Re: Response to Colorado Geological Survey Review
Soil, Geology, & Geology Hazard Study
Sterling Ranch East – Preliminary Plan No. 1
Parcel Nos. 17, 18, 22, 23, 24, 26, 37, & 38
El Paso County, Colorado
Entech Job No. 220571

CGS COMMENTS AND ENTECH ENGINEERING, INC. RESPONSES

EP-22-0102_1 Sterling Ranch East Phase I PUDSP224

SITE PLAN/TEST BORING LOCATION MAP
STERLING RANCH EAST
PRELIMINARY PLAN NO. 1
COLORADO SPRINGS, CO.
FOR: CLASSIC SRJ

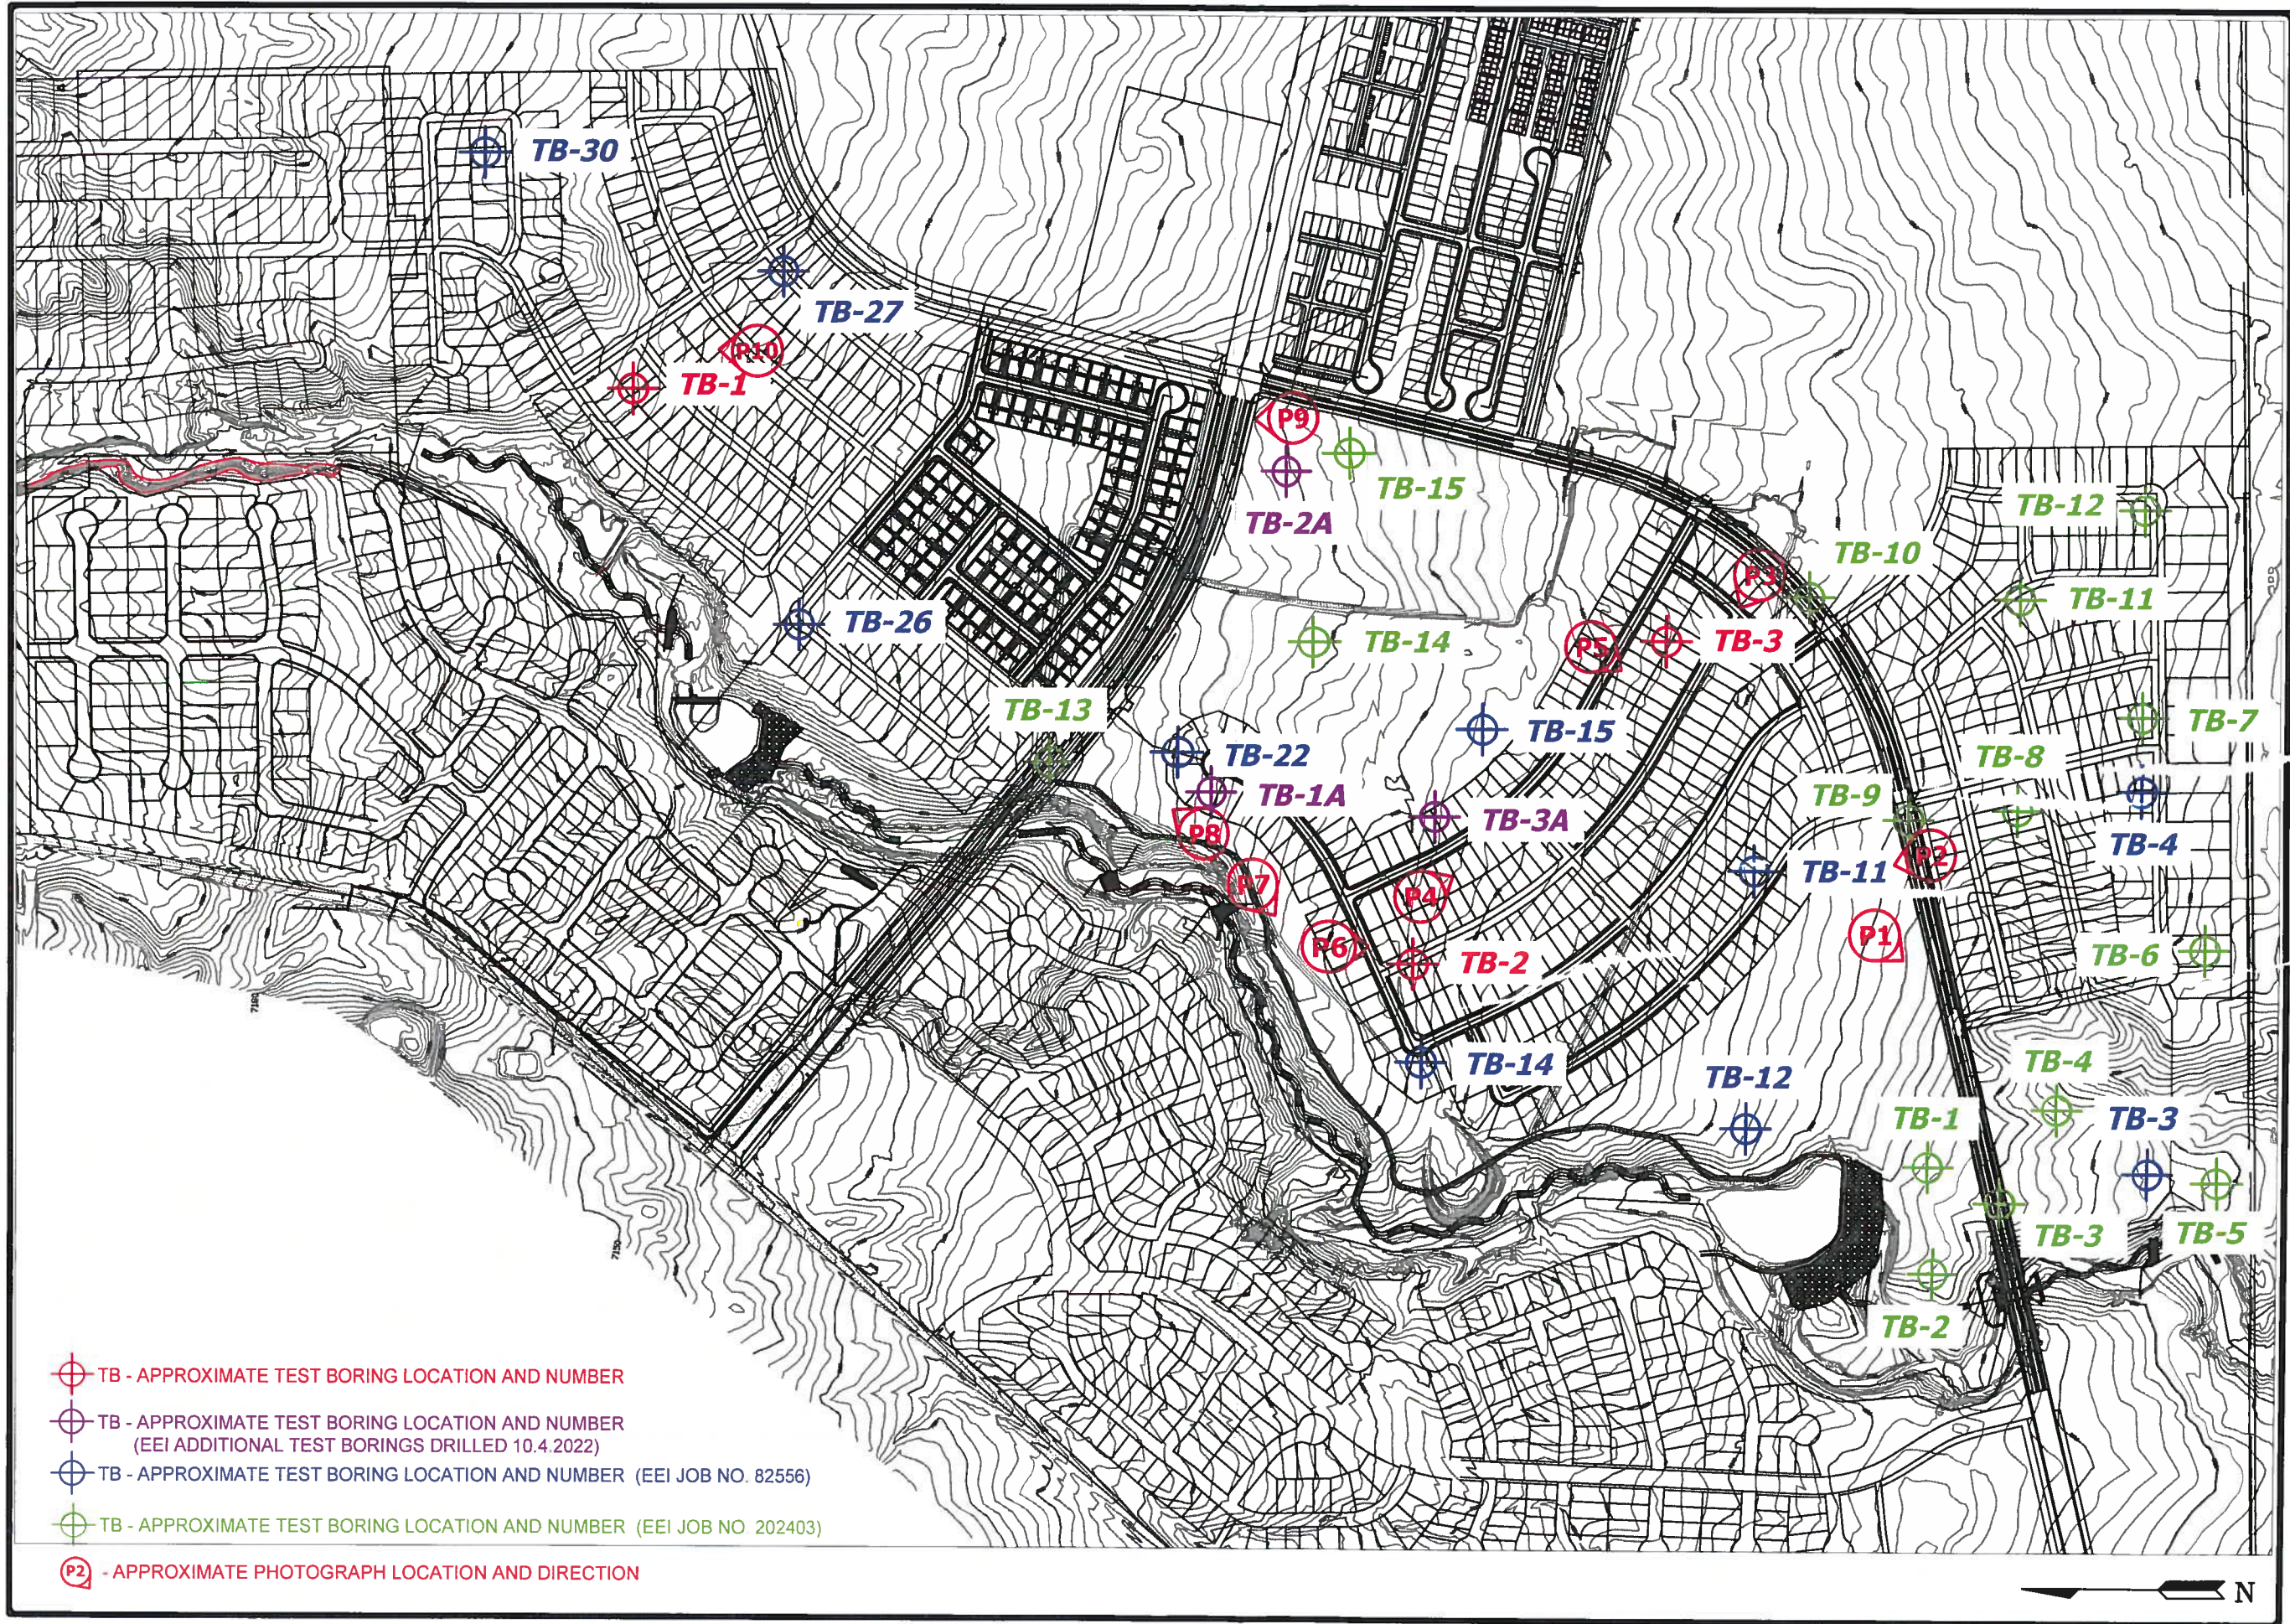
CGS Comment: *“In the test borings drilled, groundwater was encountered at 3 to 19 feet below grade during drilling, and Entech observed areas on ponded water in some locations. According to Entech (page 2), “The proposed housing will potentially utilize crawlspaces, garden level basements, or full basements.” Monitoring/observations of groundwater fluctuations have not been conducted. If basements are planned **CGS recommends the county require a groundwater monitoring/observation program prior to the preliminary plan’s approval to determine if basements are feasible and if an underdrain system could be employed for this site.**”*

CGS Comment: *“Entech’s response to CGS’s review indicated that three additional test holes were drilled, and groundwater was encountered in one of the test holes at 13 feet below grade during drilling and at 11.5 feet the following day, but also indicated that these additional test borings were drilled in October (when water levels are lower). CGS recommends that these test holes continue to be monitored through winter and spring”.*

Entech Response: Three additional test borings were drilled in the areas where groundwater was previously encountered at 3 to 3.5 feet below the surface grade, and near an area which previously had standing water. The Test Boring Location Map, and Test Boring Logs are included with this letter. Soils encountered in the test borings consisted of 3 to 9 feet of silty sand overlying slightly silty to silty sandstone and sandy claystone. Groundwater was encountered in Test Boring No. 1A at 13 feet during drilling, and at 11.5 feet the following day. Test Borings Nos. 2A and 3A

Entech Response: Additional water measurements were taken on the borings in January and May 2023, and are included on Table No. 1 of this letter. Ground water levels were measured at depths ranging from 5 to 16 feet below the existing surface grade. Test Boring No. 2A was damaged between the January and May readings.

Interceptor drains will likely be needed in areas of cuts where shallow groundwater is encountered. The groundwater depth at 3A is not expected to affect the proposed structures. Additional site investigation will need to be conducted as development plans are finalized. Basement feasibility should be determined on a block by block basis pending the results of additional site investigation and approved grading plans. Currently cuts of up to 7 feet are proposed in the general area of Test Boring No. 1A.
